Drainage Strategy at the Land Adjacent to 68 Knoll Crescent, Northwood

Revision B

PA445 3, 19, 20, 37, 38 REVISED

Figure 4.2: The soil types under the project site – sandy (reference - UKSO map¹⁶).

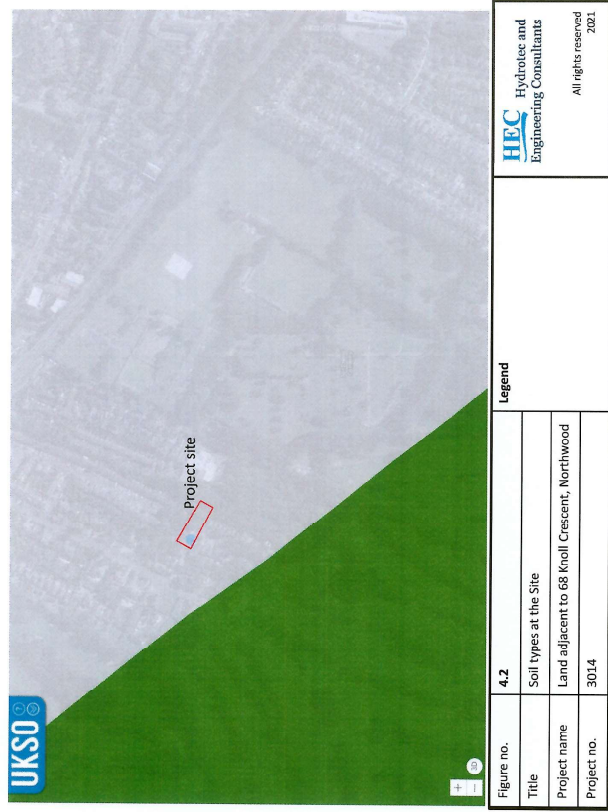
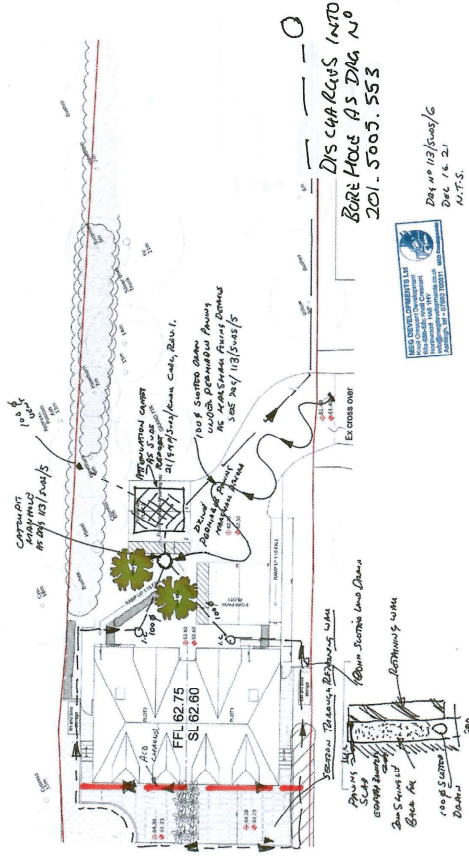
To assess the attenuation of the generated surface water runoff through infiltration, the soil types around the project site were obtained from the UK soil observatory (UKSO) map¹⁵ and presented in Figure 4.2. There is no detailed data available below the Site however, the soil types in the west close to the Site are rich-loamy and clayey with impeded draining. Consequently, the surface water infiltration capacity within and around the project site could be relatively less. Thus, it would not assist a substantial reduction of surface water runoff through infiltration into the ground and consequently, the soakaway design at the Site would not be suitable.

The map below shows the soil types around the project site. The soil types are rich-loamy and clayey with impeded draining. Consequently, the surface water infiltration capacity within and around the project site could be relatively less.
